90-09-10 TEXAS INSTRUMENTS: Amendment 39-6565. Docket No. 89-ANE-38.

94-21-06 PACIFIC SCIENTIFIC COMPANY, HTL/KIN-TECH DIVISION:
Amendment 39-9048. Docket 94-NM-73-AD.

Examples of Bolt Head Markings
FIGURE 2

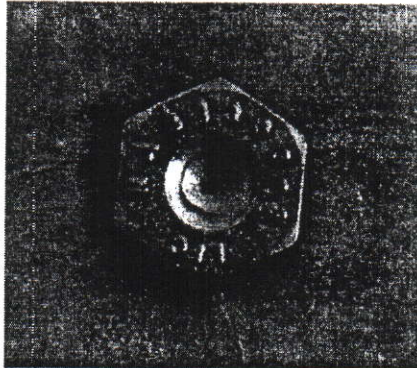
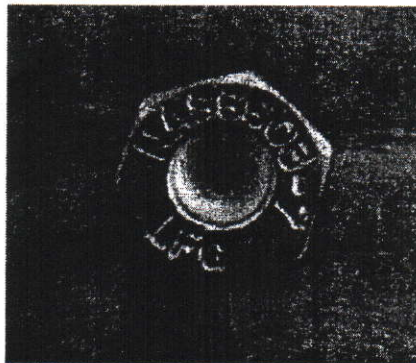
3. Verify the installed bolts are the approved part numbers NAS1303 or NAS6603. If approved bolts are installed proceed to Step 6. Refer to Figure 2.
4. Remove and replace any unapproved bolt part number with an approved bolt part number. Refer to 1124/1124A Westwind Illustrated Parts Catalog, Chapters 54-20-00 and 78-30-00 for proper bolt part numbers.
